Form 3160-5 (June 2019)	UNITED STATES DEPARTMENT OF THE INTERIOR BUREAU OF LAND MANAGEMENT	FORM APPROVED OMB No. 1004-0137 Expires: October 31, 2021
SUNDRY NOTICES AND REPORTS ON WELLS <i>Do not use this form for proposals to drill or to re-enter an abandoned well. Use Form 3160-3 (APD) for such proposals.</i>		5. Lease Serial No. JIC92

Proposed Plug and Abandonment Procedure

Jicarilla 92 18A

Attachment to notice of Intention to Abandon

Proposed Wellbore Schematic

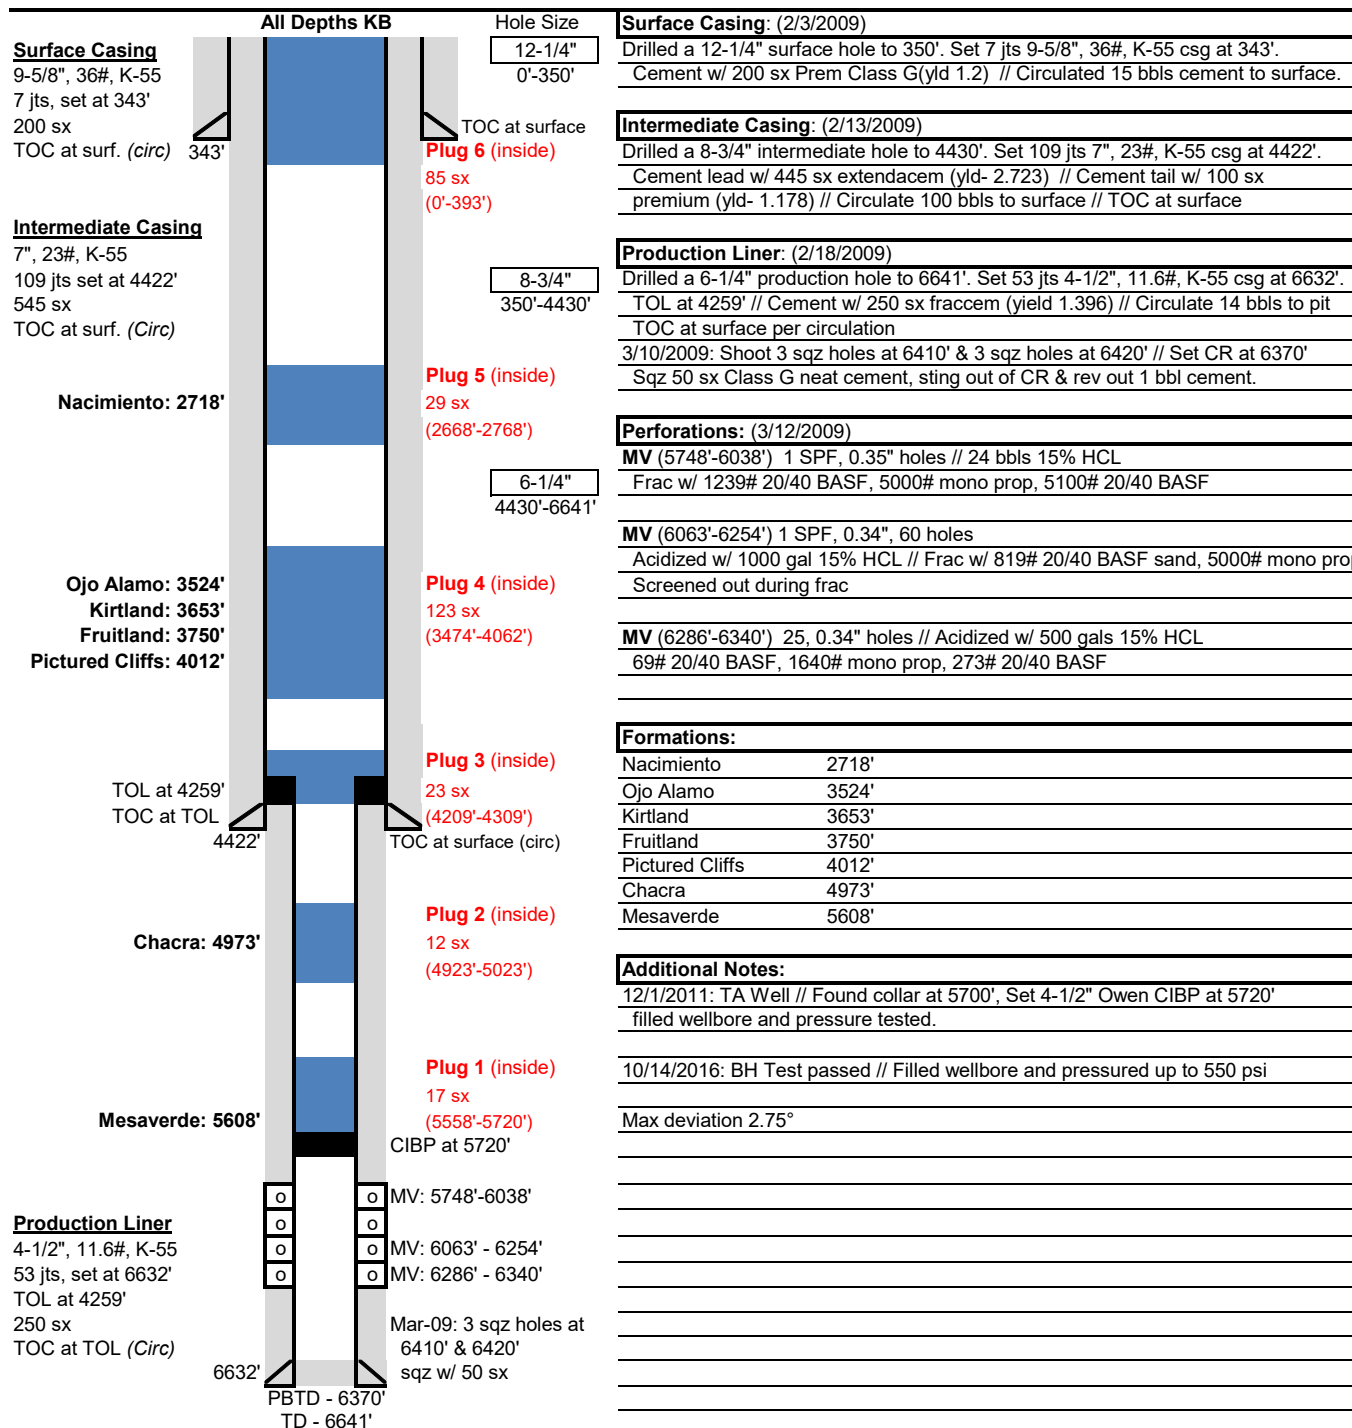
3. The following modifications to your plugging program are to be made:
 - a. Add a plug to cover a minimum 50 ft below and above the BLM selected formation top location of the Chacra at 4973 ft-depth.

- b. Adjust plug 3 bottom to cover 50 ft below Pictured Cliffs formation top location selected by the BLM at 4012 ft-depth. 4062 ft, or deeper, should be plug 3 adjusted bottom location.

- c. For the BLM selected formation top location of the Fruitland at 3750 ft-depth, it is recommended to combine plug 3 and 4. Or an adjustment to cover a minimum 50 ft above and below the location.

Limited raster log data for the formation tops of Mesaverde and Chacra. The Apache #001E reference well justifies the locations selected by the BLM. Mesaverde/ Cliff House top at 5740 ft-depth. **Chacra top at 4973 ft-depth.** The proposed plug by the operator for the Mesaverde is still appropriate. Even though the CIBP is already set 20 ft higher than the BLM location. **A plug will have to be added for the Chacra top location.**

The raster log data and Tribal 05 #001 justifies the formation top locations selected by the BLM for the Pictured Cliffs and Fruitland. **Pictured Cliffs top at 4012 ft-depth. Fruitland top at 3750 ft-depth.** Plug 3 bottom need to be adjusted to be 50 ft below Pictured Cliffs depth. 4062 ft, or deeper, should be plug 3 adjusted bottom location. **It is recommended to combine plug 3 and 4 to account the BLM location for the Fruitland top. Or an adjustment to cover a minimum 50 feet above and below the location.** The formation tops of the Kirtland to Nacimiento selected by the operator are appropriate.
